File No. 170750 Committee Item No. 5
 Board Item No. 24

1 [General Plan Amendments - One Oak Street Project]

2
3 **Ordinance amending the General Plan by revising the height and bulk designations for**
4 **the One Oak Street project, at the Van Ness Avenue / Oak Street / Market Street**
5 **Intersection, Assessor's Parcel Block No. 0836, Lot Nos. 001 and 005, on Map 3 of the**
6 **Market and Octavia Area Plan and on Map 5 of the Downtown Area Plan; adopting**
7 **findings under the California Environmental Quality Act; making findings of**
8 **consistency with the General Plan as proposed for amendment, and the eight priority**
9 **policies of Planning Code, Section 101.1; and adopting findings of public necessity,**
10 **convenience, and welfare under Planning Code, Section 340.**

RE: Appeal Timeliness and Standing Determination – 1500-1540 Market (One Oak Project), Planning Department Case No. 2009.0159E

(REVISED) FIGURE 4.E.1: LOCATION OF AFFECTED PARKS IN RELATION TO PROPOSED PROJECT

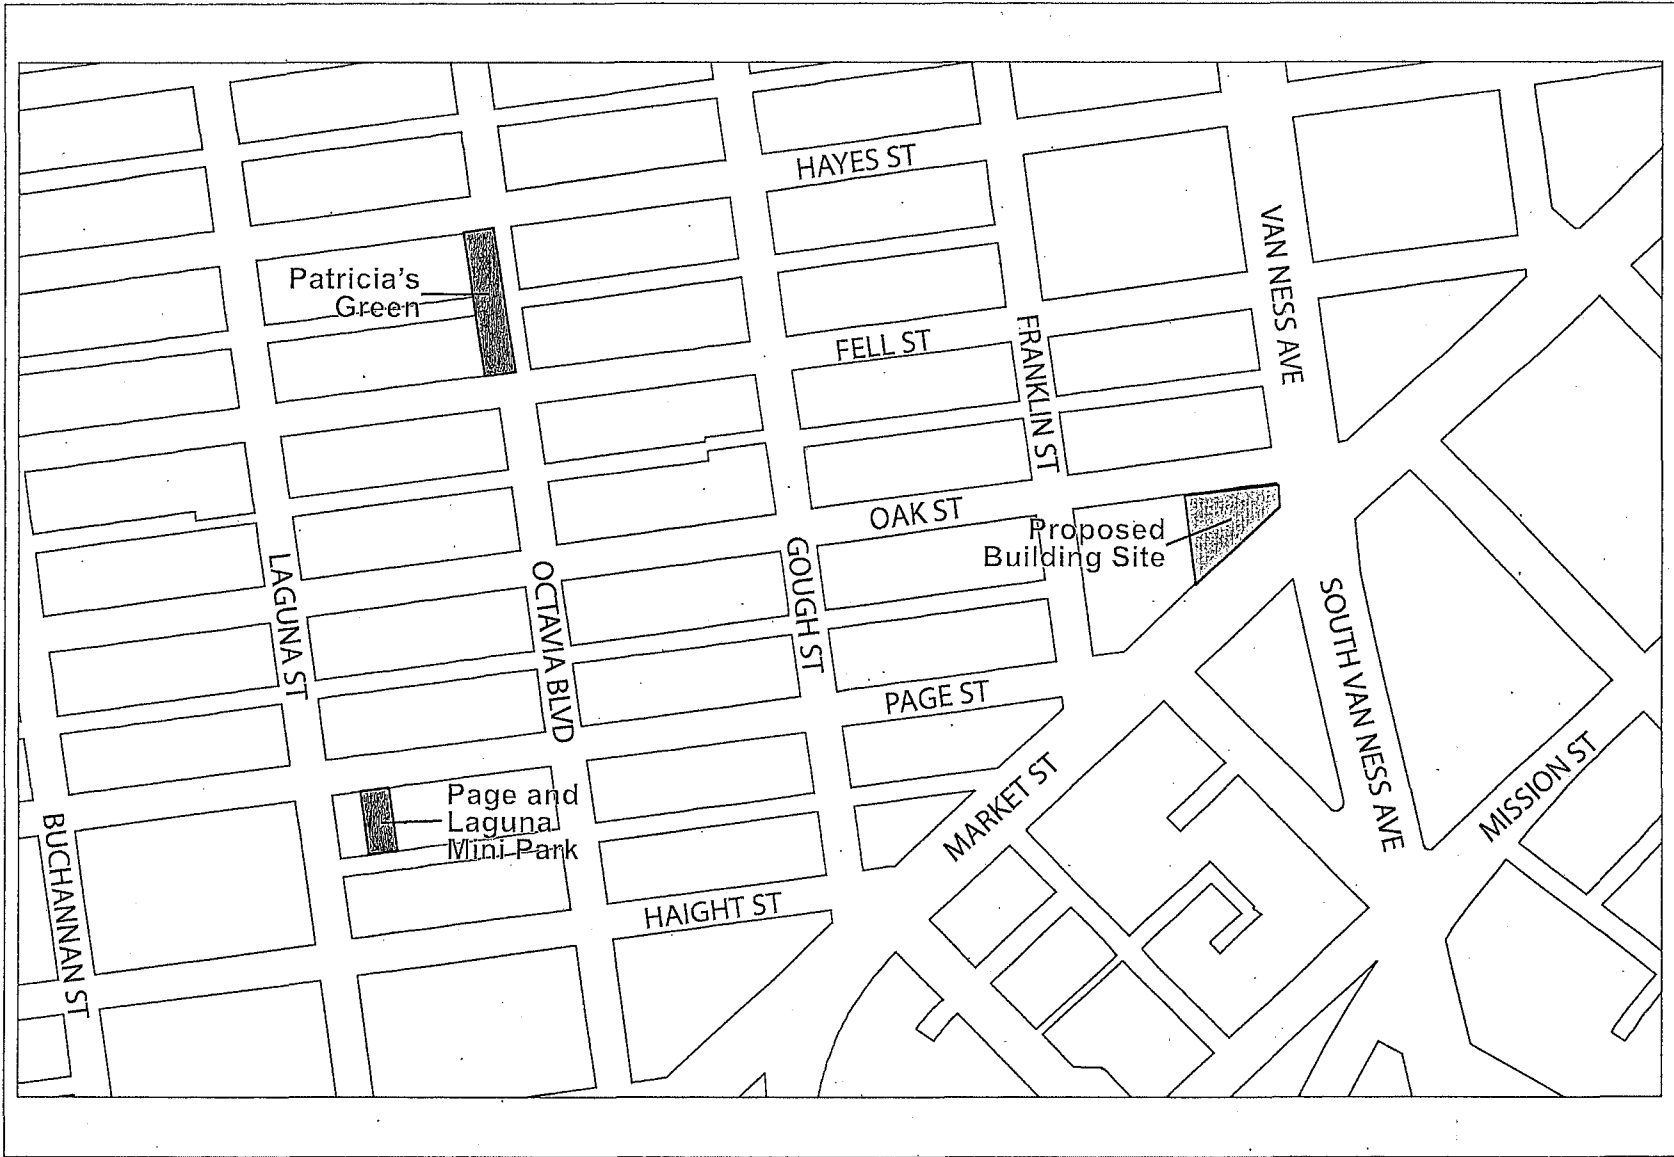
- * Figure 4.E.1: Location of Affected Parks in relation to the Proposed Project, on EIR p. 4.E.2, has been revised to remove Koshland Park. The revised figure is shown on the following page.
- * On EIR p. 4.E.5, the second and third paragraphs have been deleted to remove reference to Koshland Park, and the fourth paragraph has been revised to introduce (Revised) Figure 4.E.2: Page and Laguna Mini Park, as follows (new text is underlined and deletions are shown in ~~strikethrough~~):

(REVISED) FIGURE 4.E.3 MAXIMUM NEW PROJECT SHADOW ON PATRICIA'S GREEN
8:30 AM ON OCTOBER 4 / MARCH 8

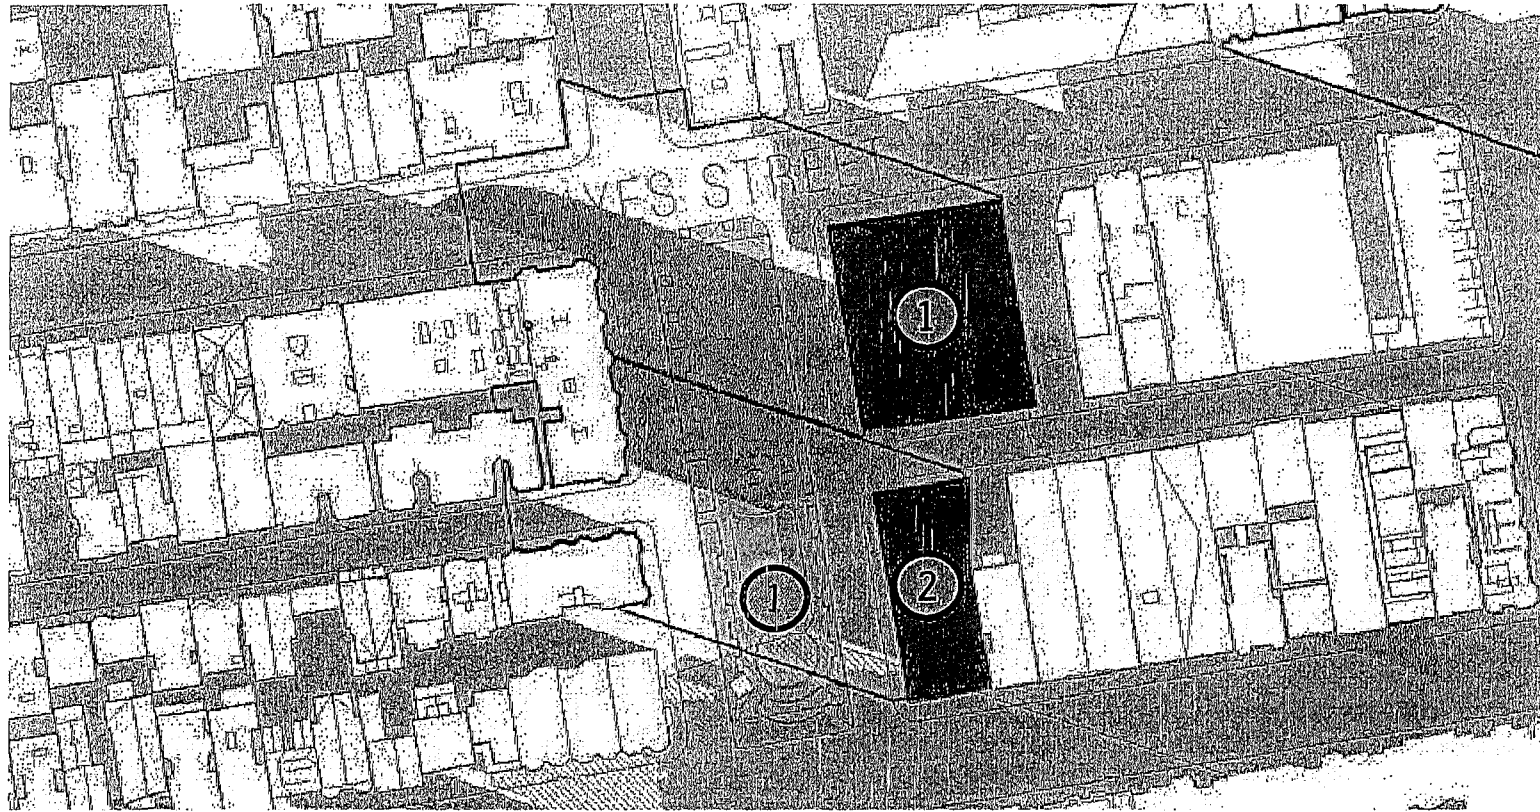
- * DEIR Figure 4.E.3: Maximum Extent of New Project Shadow on Patricia's Green, 8:30 AM on October 11/March 2, on EIR p. 4.E.15, has been revised to use the updated shadow projection diagram provided by PreVision, as shown on the following page.

(REVISED) FIGURE 4.E.5 FORESEEABLE PROJECTS

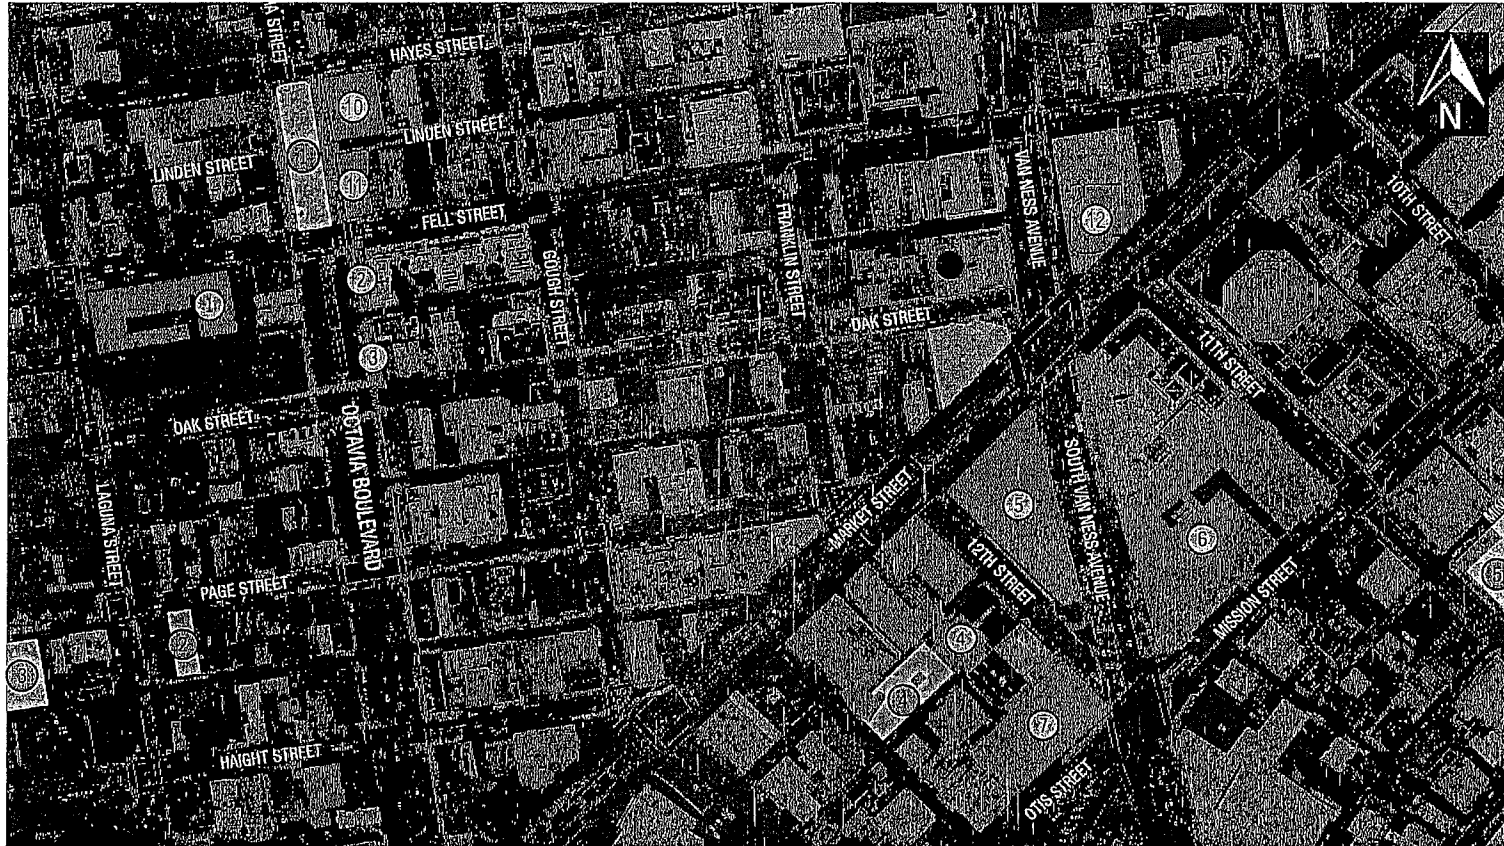
- * Accordingly, DEIR Figure 4.E.5: Foreseeable Projects, on EIR p. 4.E.23, has been revised to use the updated map of foreseeable projects provided by PreVision, as shown on the following page.
- * Accordingly, the quantitative cumulative impact evaluation for Patricia's Green, beginning with the first complete paragraph on EIR p. 4.E.24 and ending with the last full paragraph on EIR p. 4.E.26 has been revised, as follows (new text is underlined and deletions are shown in ~~strikethrough~~):

Proposed General Plan & Zoning Map Amendment

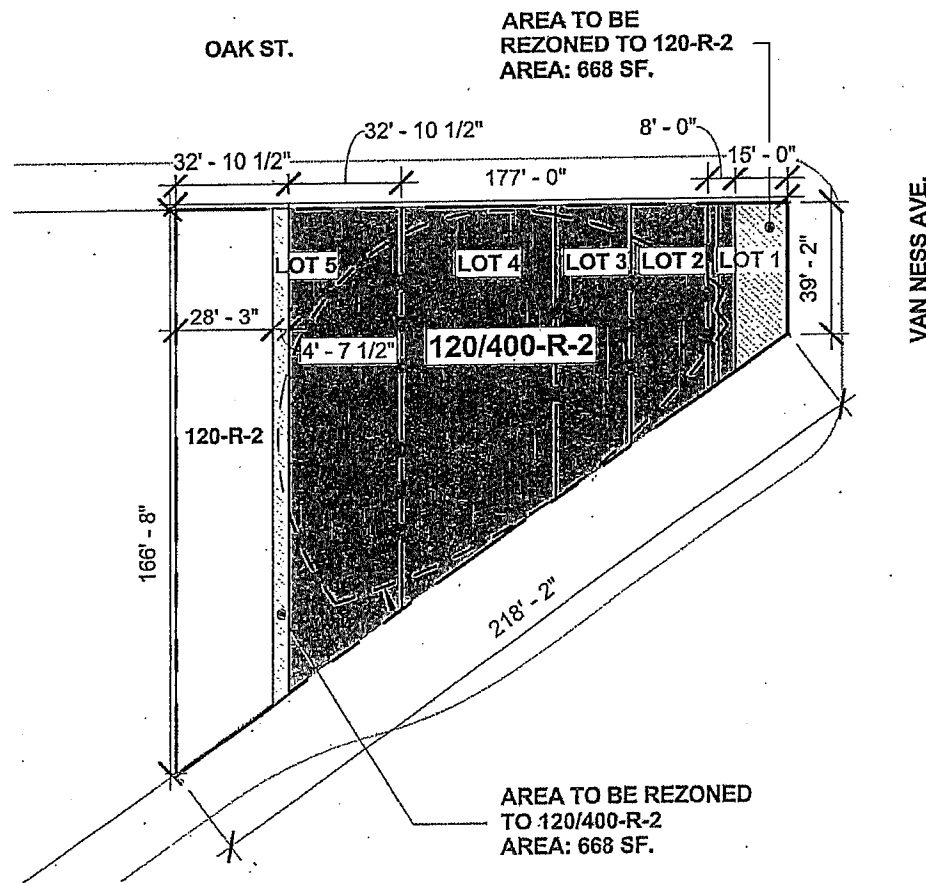
18 Revise Map 3 to reclassify the height limit of the eastern 15 feet of Assessor's Block
19 0836, Lot 001 from 400' tower/120' podium to 120', and a 4'-7.5" wide area located 28'-3" from
20 the western edge of Assessor's Block 0836, Lot 005 from 120' to 400' tower/120' podium as
21 described below:

14 Revise Map 5 to reclassify the height and bulk of the same Assessor's Block and Lots
15 from 150-S and 120-F to 120-R-2 and 120/400-R-2 as described below:
